**1<sup>st</sup> Further Information**

**Proposed Temporary Warehouse (Excluding Dangerous Goods Godown) with Ancillary Facilities  
for a Period of 3 Years and Associated Filling of Land and Pond in “Agriculture” Zone,  
Lot 1434 (Part) in D.D. 107, Kam Tin, Yuen Long, New Territories**

**(S.16 Planning Application No. A/YL-KTN/979)**

Drainage Appraisal

DRAWING NUMBER:  
**FIGURE 3**

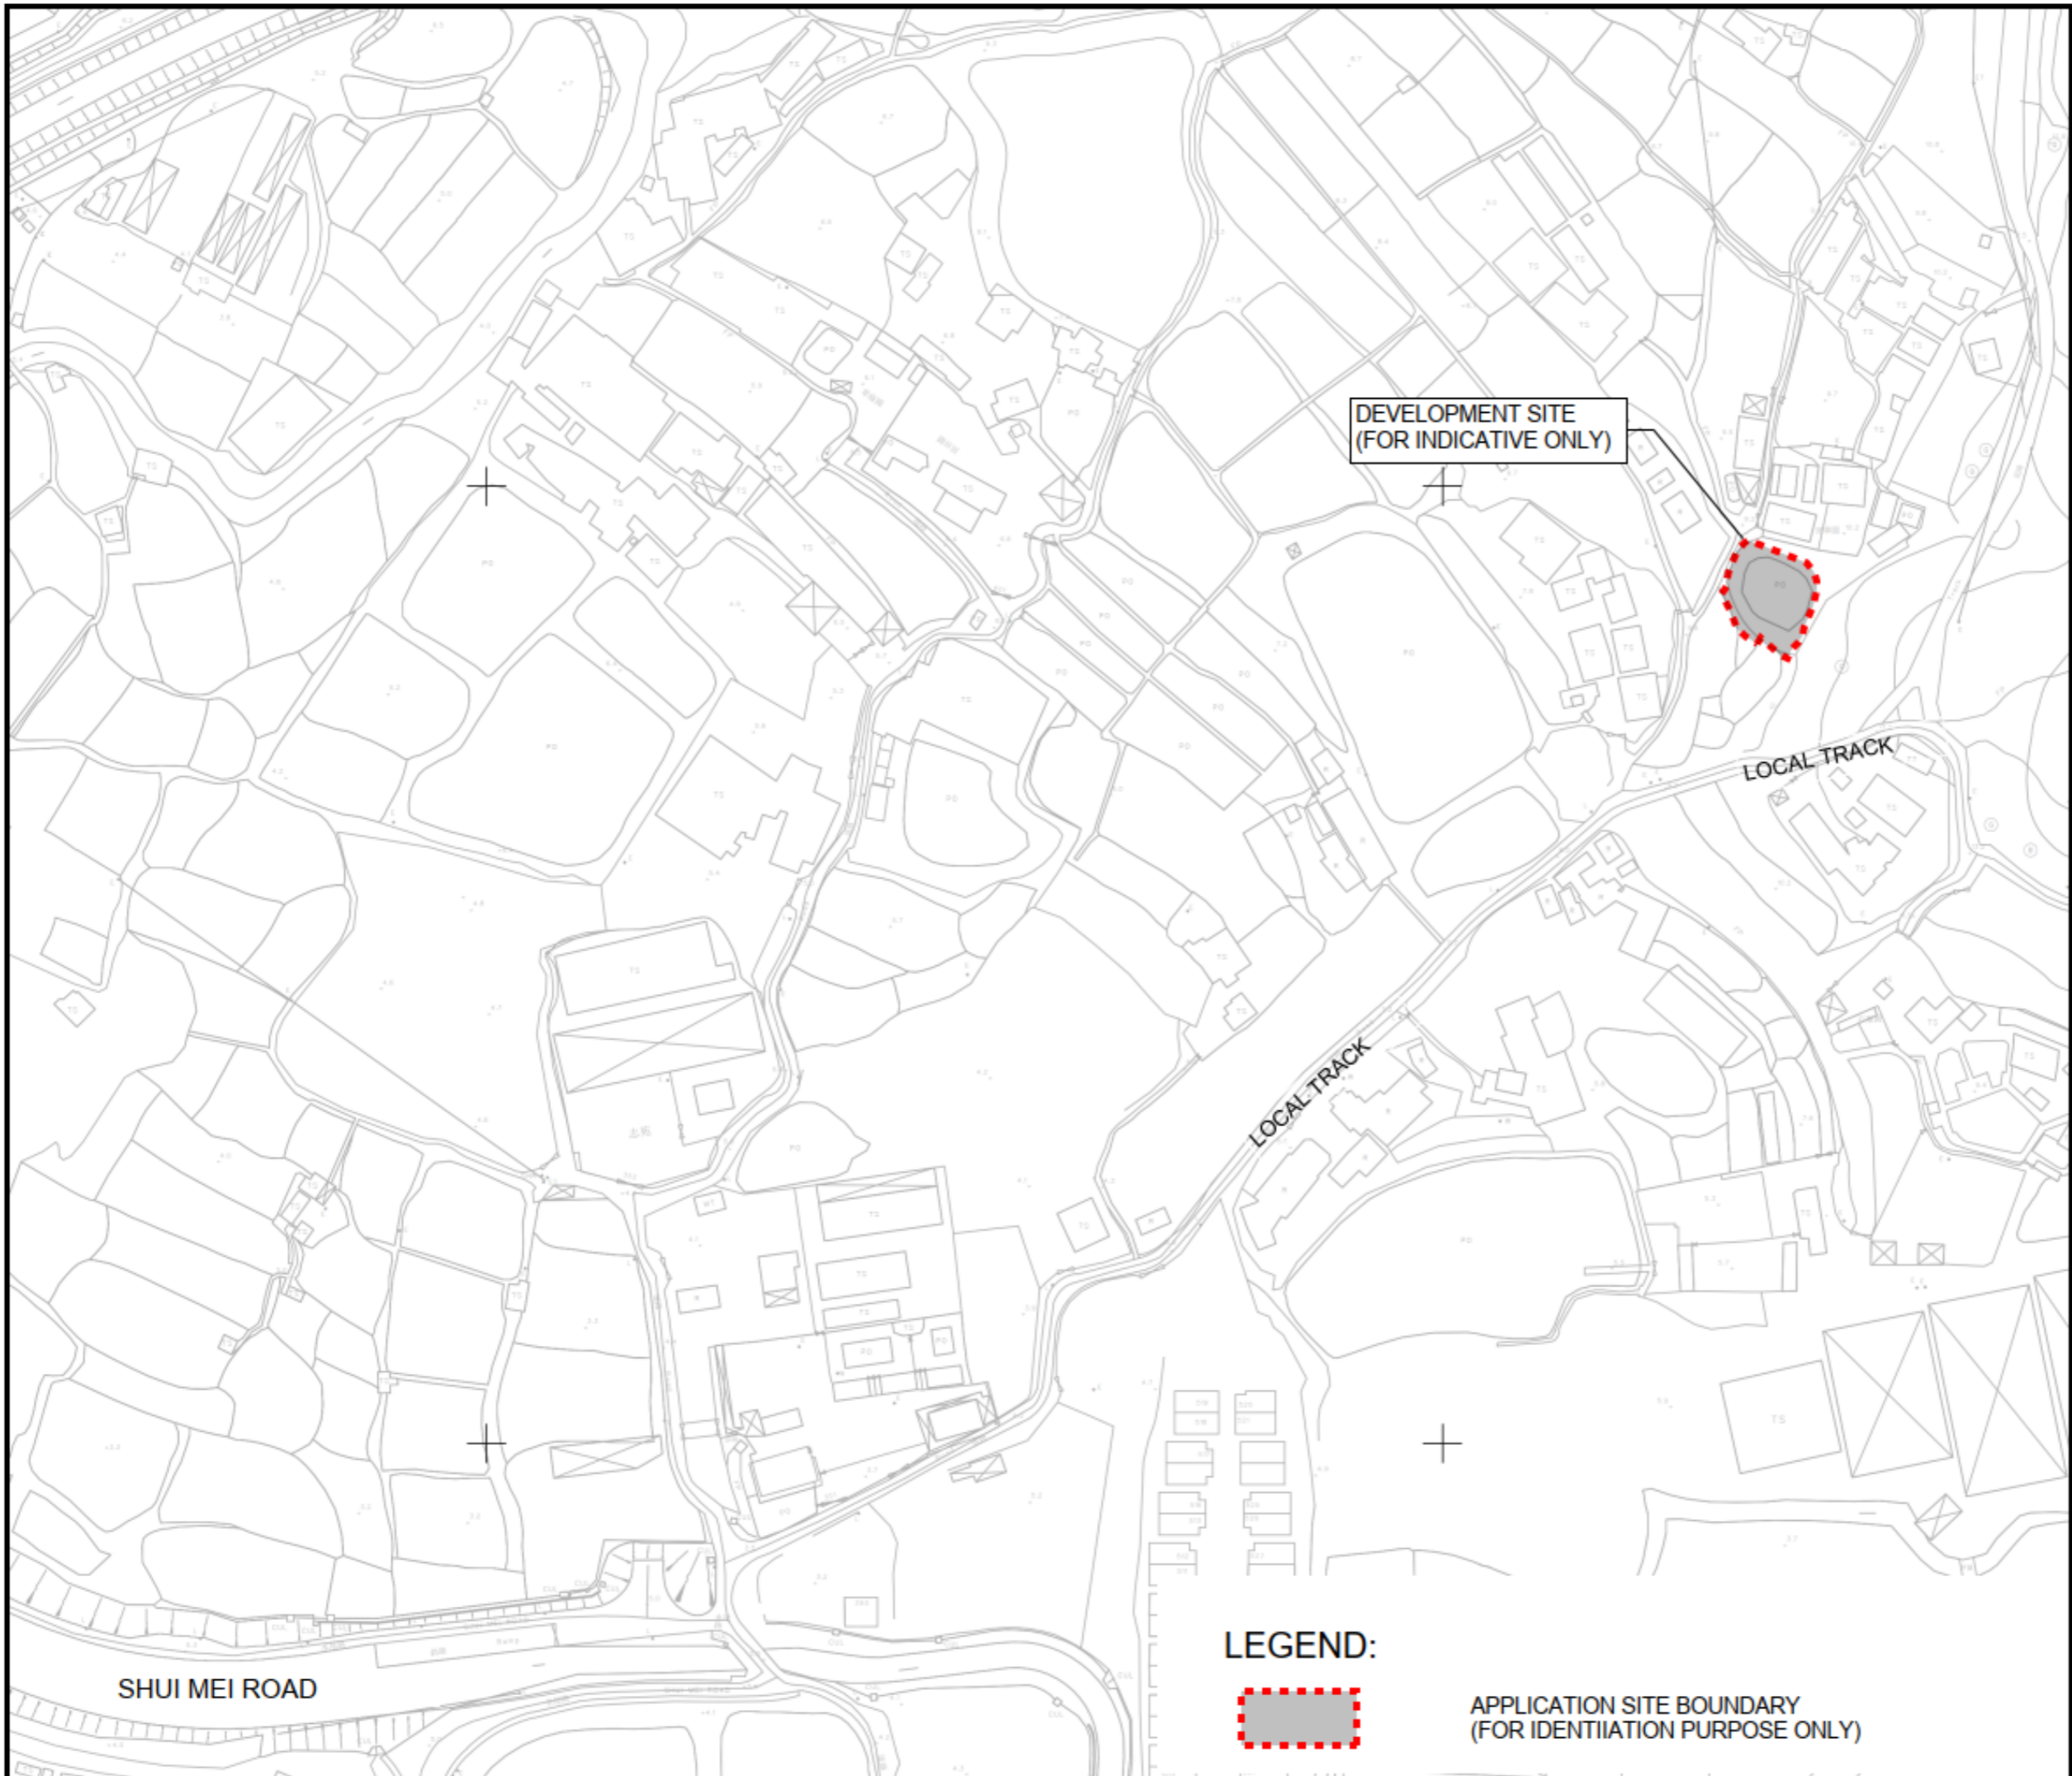
(a)	I have reservation on the subject development as there as proposed pond and land filling works and appears covering the whole application site but there is no substantiation show how the overland flow from adjacent areas would not be interrupted by the proposed works.	A drainage proposal, with provision of peripheral u-channel and catchpits is provided to mitigate potential drainage impact generated by the proposed development ( <b>Annex I</b> ). The applicant will implement the proposed drainage facilities at the application site (the Site) once the drainage proposal is accepted by CE/MN, DSD / Town Planning Board.
<b>2. Comments of the Director of Agriculture, Fisheries and Conservation (DAFC)</b> <b>(Contact Person: Ms. WONG Cheuk-ling; Tel: 2150 6933)</b>

<p>has the potential to be used for fish culture operations in the future. As such, the application is not supported from a fisheries viewpoint.”</p>	<p>requirements from DSD, including the provision of peripheral u-channels and catchpits to mitigate the potential adverse drainage impact generated by the proposed development. Therefore, direct impact to the fish pond should not be anticipated.</p>
--	---	--

- 4.1.1 The Application Site and the surrounding areas are generally flat. Internal drainage system is proposed to collect the runoff from the application site and discharge to the existing drainage system under the local tracks at the south. The alignment, size and gradient of the proposed drains are shown in **Figure 3**.
- 4.1.2 The design calculations of proposed channels are shown in **Appendix A**.
